2947 EASTLAKE

2947 Eastlake Ave E, Seattle WA

8.0 EDG SUMMARY

8.0 ITEMIZED RESPONSE TO EDG

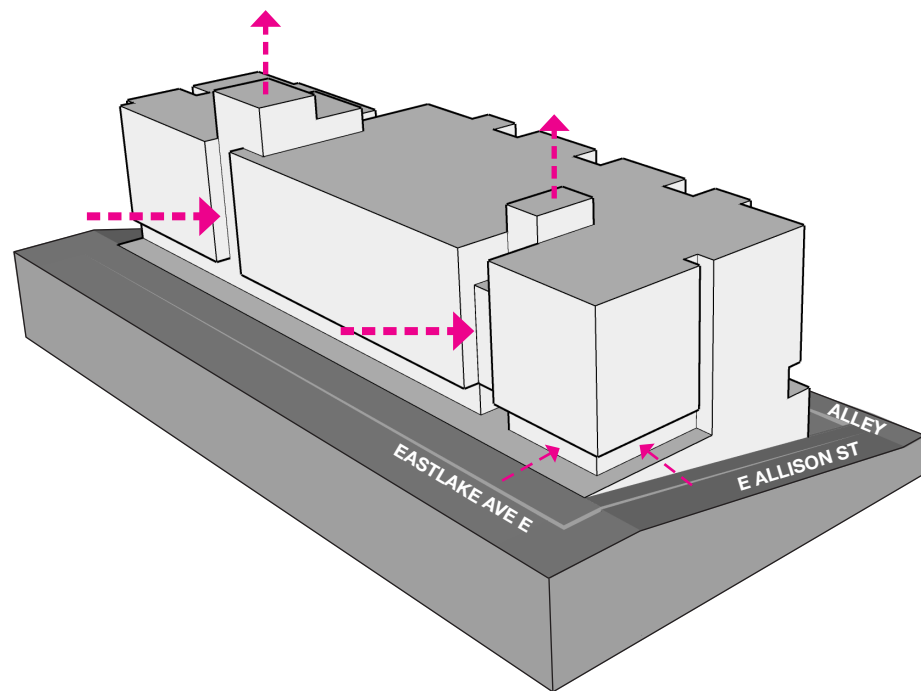
- 1a) The board unanimously supported Option 3 (the applicants preferred scheme) noting the deep facets that separate the building in to three masses and help mitigate the height, bulk, and scale of the project. (CS2-D, DC-2)

Response:
Comment upheld.

1c

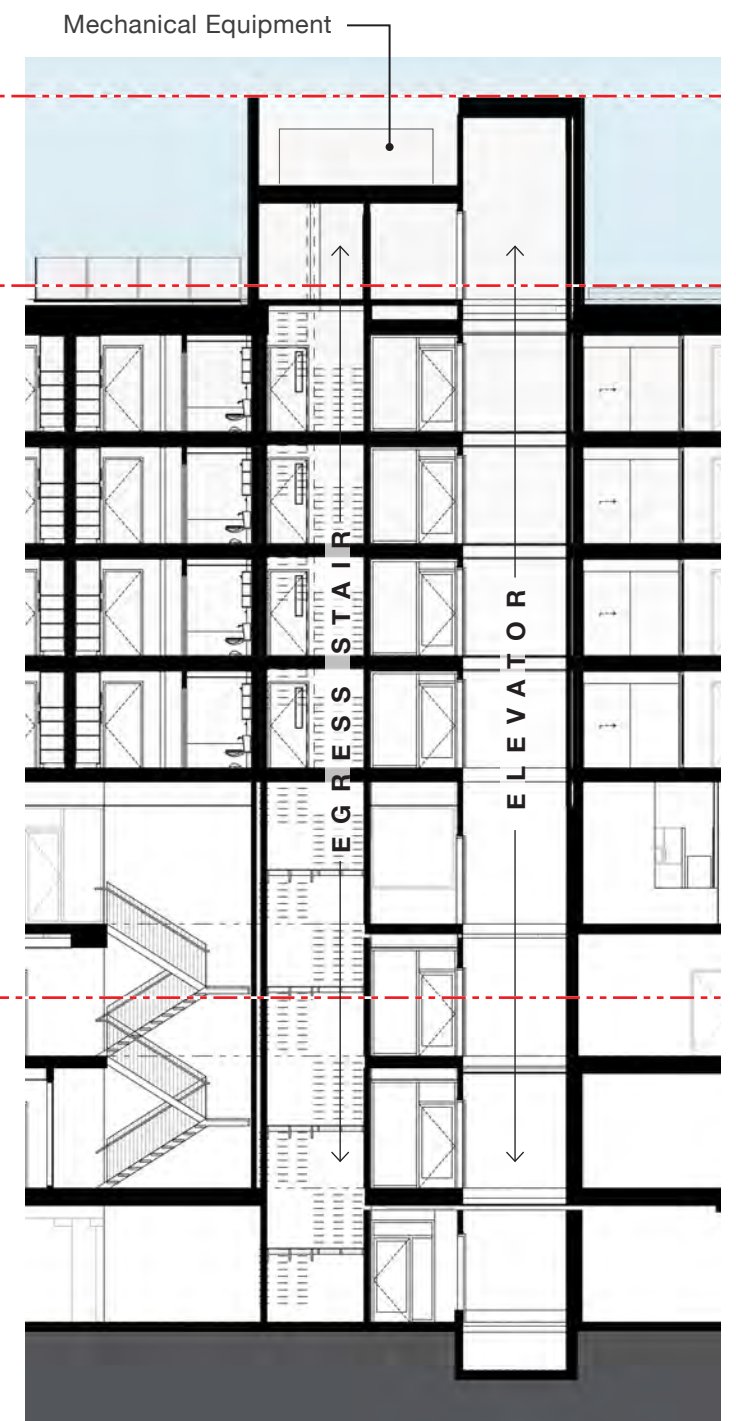
c) The board questioned the height and size of the mechanical penthouse in the preferred option and asked to have details explaining its use and composition for the Recommendation phase of review. (CS2-D, DC-2-A)

The height and size of the mechanical penthouse is required for the elevator overrun and to screen mechanical equipment. The penthouse complies to SMC 23.47A.012.4F, granting stair and elevator penthouses to extended up to 16' above the applicable land use height limit.

PROPOSED - STREET SECTION & PLAN AT LIVE/WORK UNITS

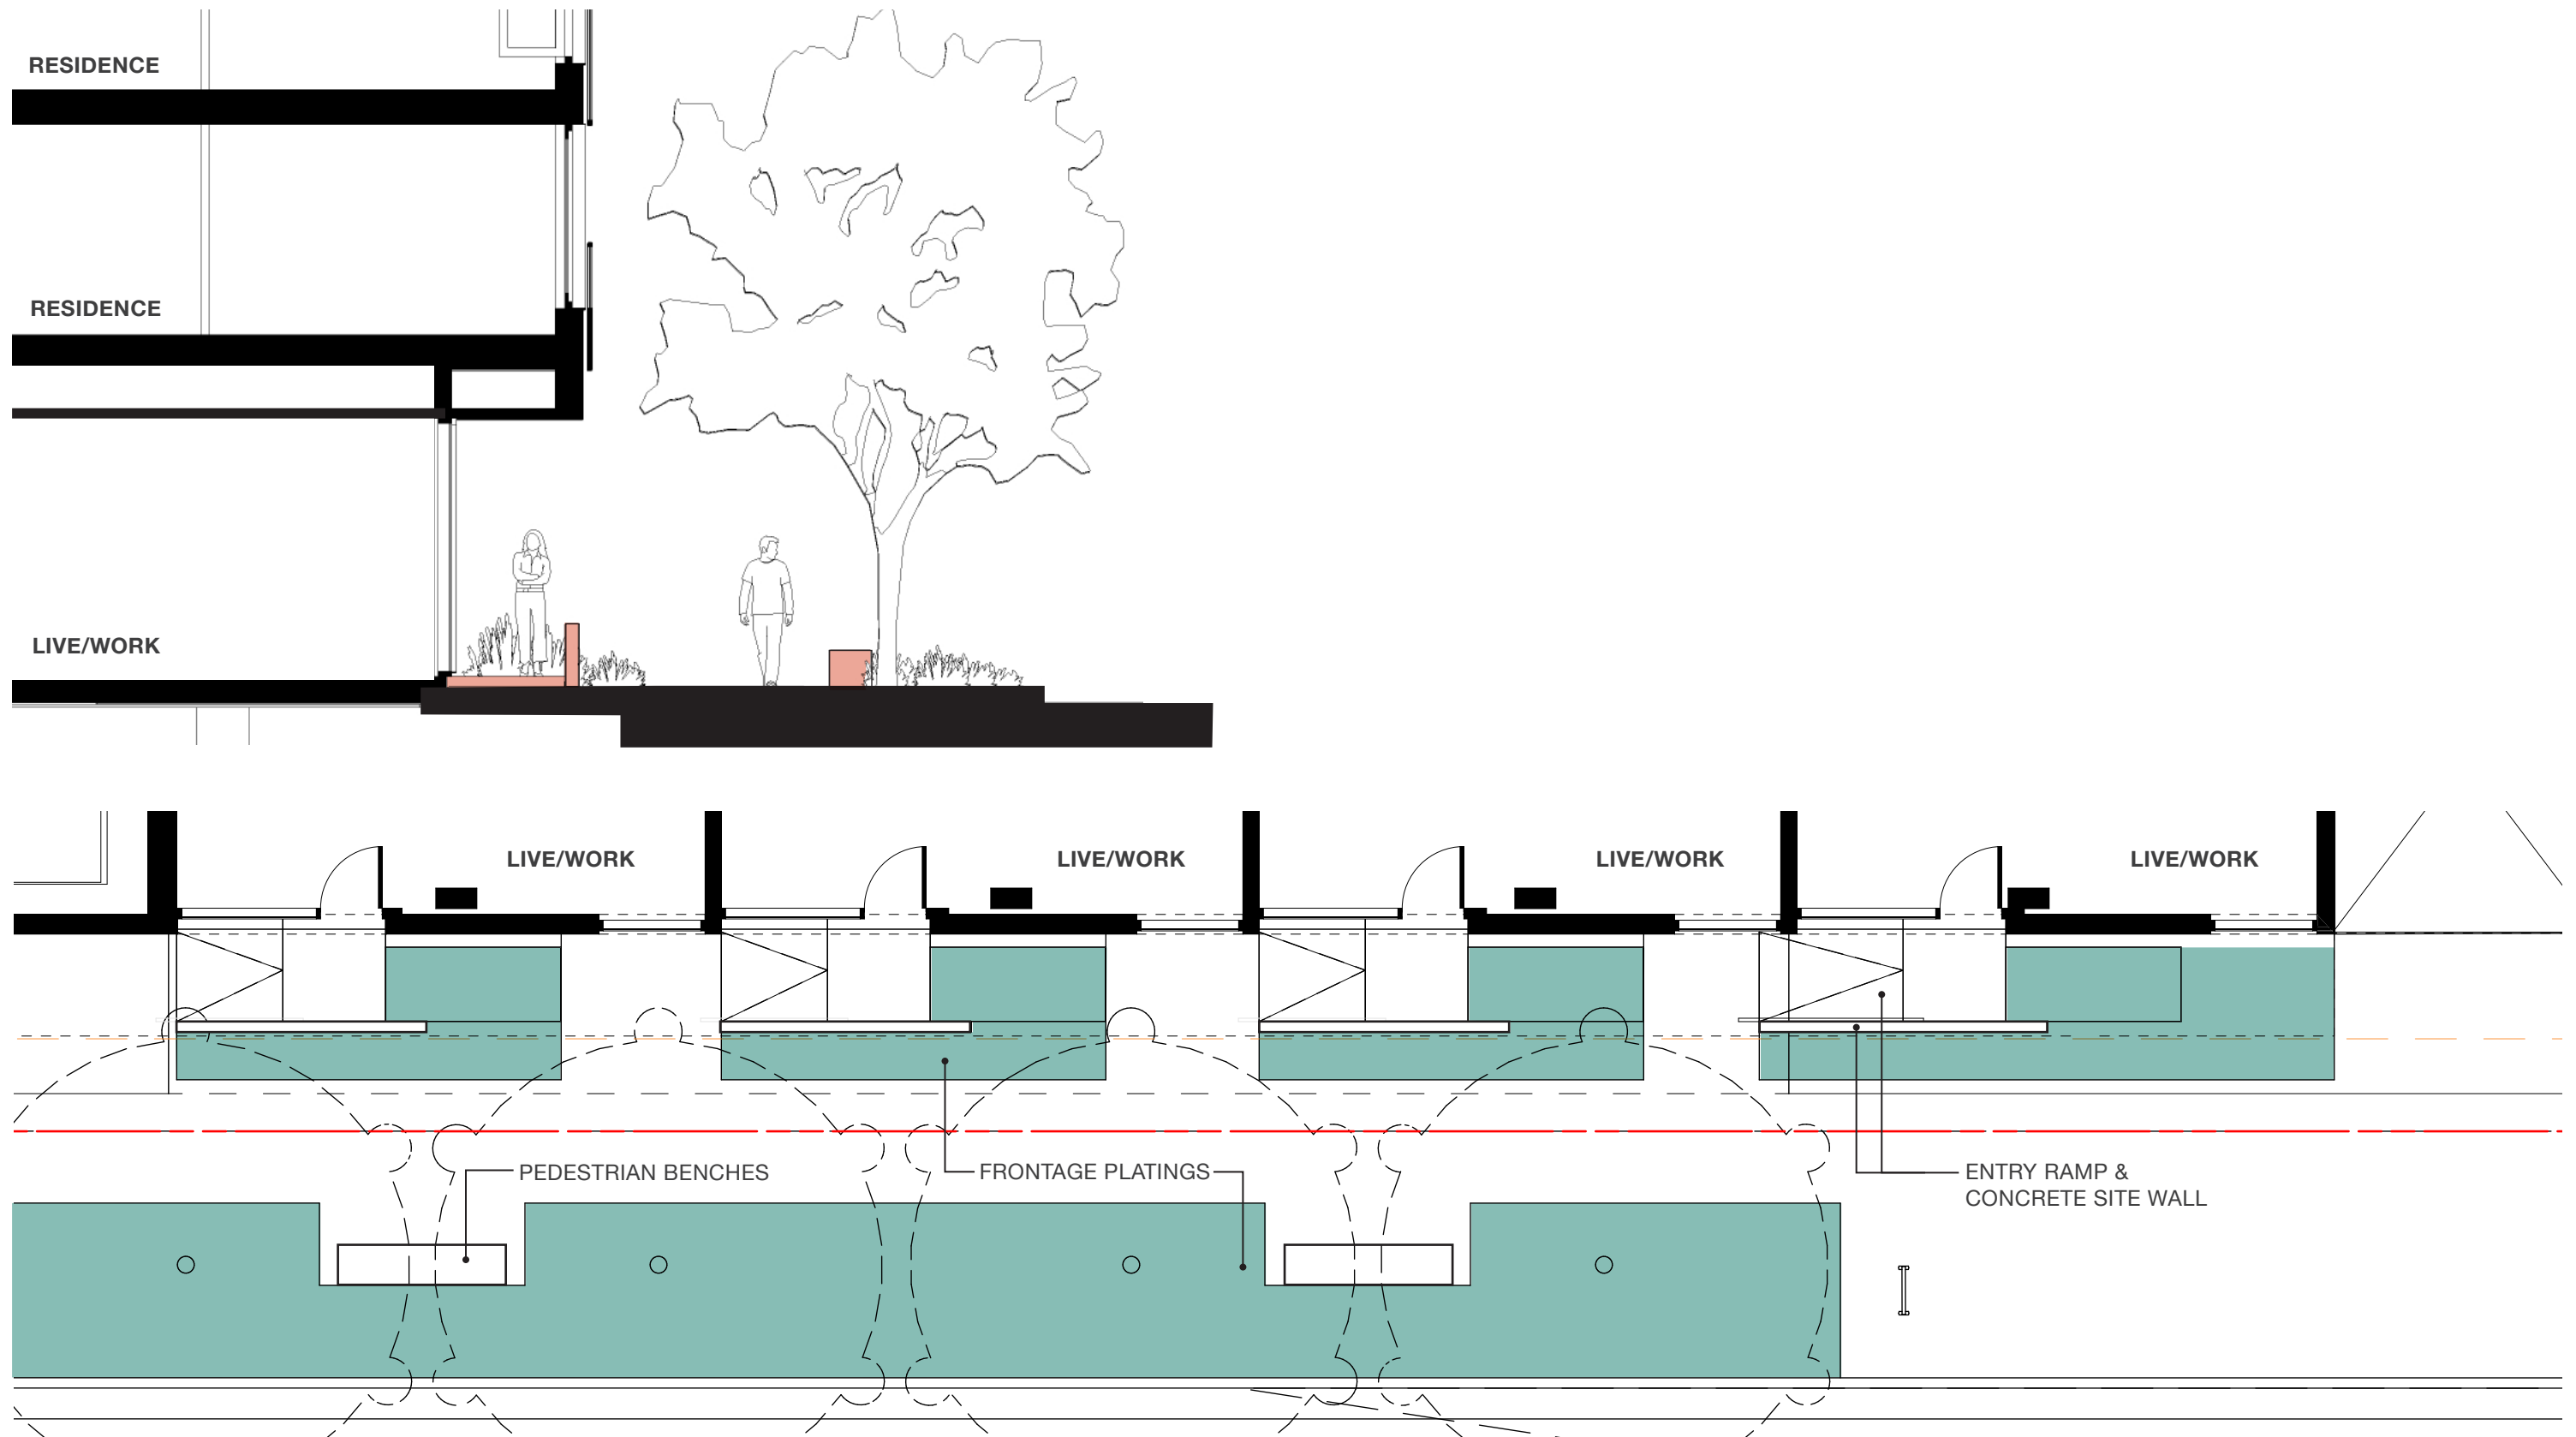
3b b) The Board expressed unanimous concern regarding the ability of the live work units on Eastlake to actively engage the street edge, particularly given the challenge of creating viable separation between commercial and residential uses in single story units. The Board agreed that this programming choice often resulted in awkward apartments with curtains drawn, and that particular care would be required to create an edge that fosters human interaction. (PL3-A, CS2-B, PL3-B, PL3-C, PL3)

Response:
The entrance to each Live/Work unit integrates a ramped surface and low concrete stem wall surrounded by a landscape buffer. These elements create a border and well defined boundary between the Live/Work units and the public realm of the sidewalk. Pedestrian benches between the street trees provide additional points of interest and activation for retail uses along Eastlake Ave E.

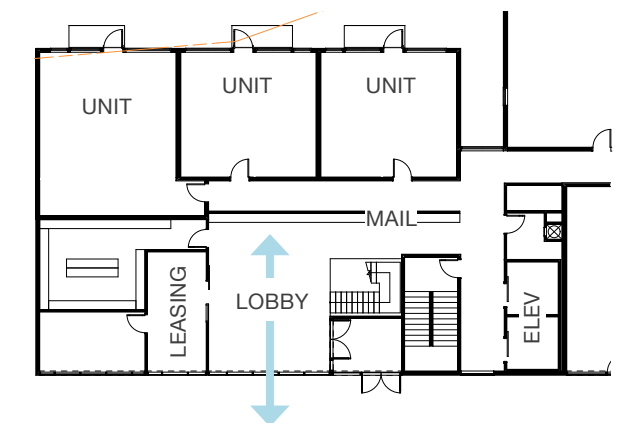
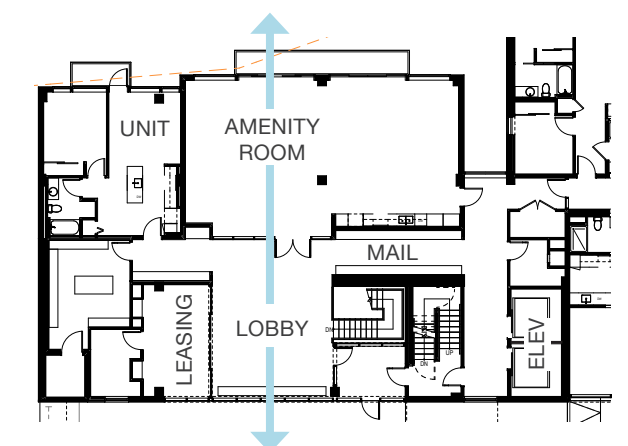
3d d) The Board agreed that the entry lobby and associated uses (including leasing and back of house uses proposed at the street frontage) did not appear to be configured in a manner that would create activity and foster human interaction as called for in the Guidelines. The applicant provided additional information regarding the development of the lobby design and intention to eliminate residential units, in favor of communal space that would be extensively glazed and visually connected to the street and to the lake beyond. The Board unanimously supported this design intent. (PL3, DC3-A)

Response:
Comment upheld. See below.

SECTION A - ALLEY

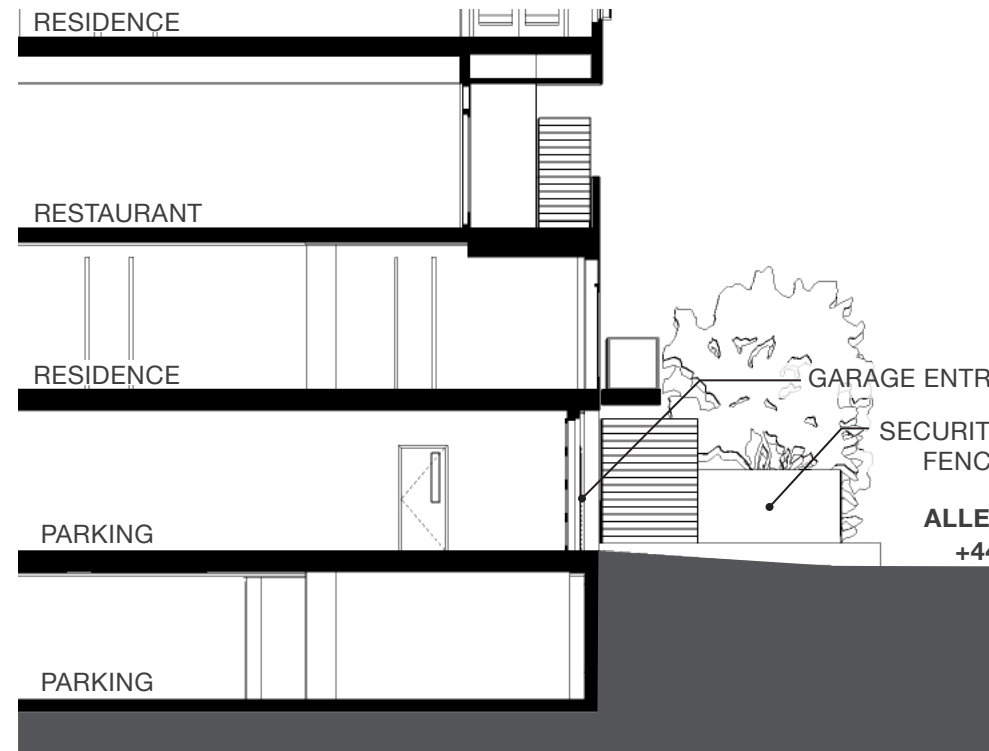
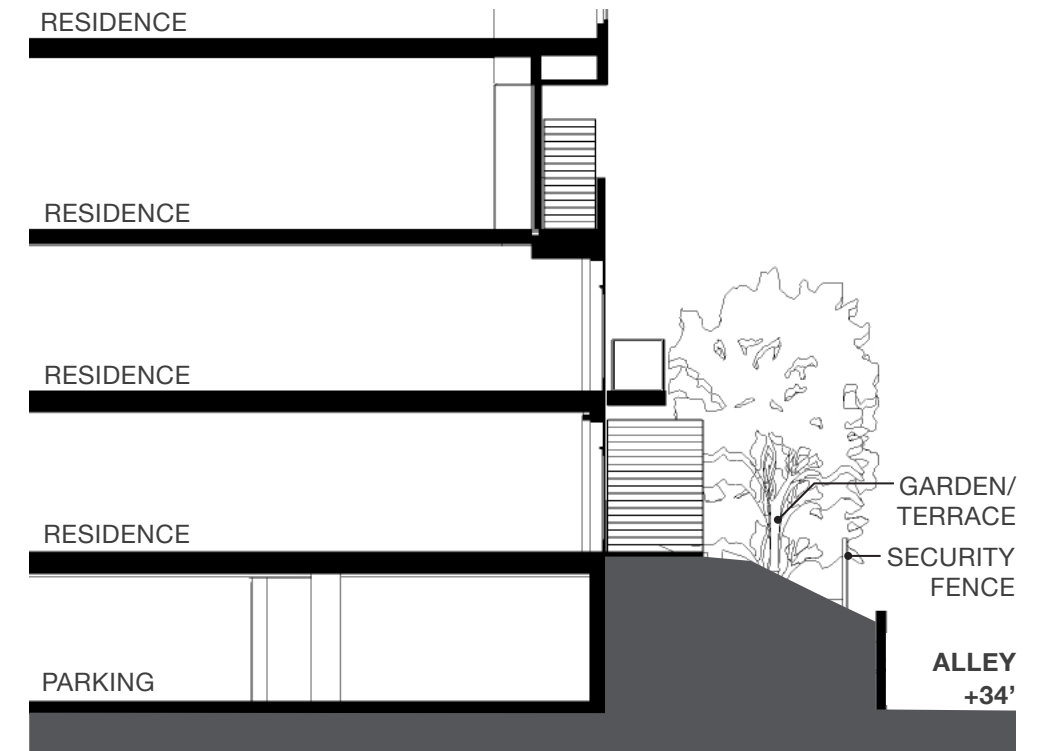
a) The Board expressed general support for the creation of a residential entrance on E. Allison Street and for the composition of the additional development shown at the alley edge. However, the Board agreed that limited information in the EDG packet made it difficult to understand these areas, particularly retaining walls and bioretention, and how each responded to the significant grades. For the next review phase please include complete details including orthographic and perspective drawings showing this information. (CS1-C, CS1-E.2, CS2-B, PL1)

The proposed design integrates residential units and a buffer of garden terraces on Level P1. The alley grades take advantage of the sloped site to provide parking garage entrances on Levels P1 and P2. A concrete retaining wall and security fence with integrated plantings maintain consistent grades for the patio and garden spaces. These elements provide a residential character to the alley while responding to the changing grades of the alley.
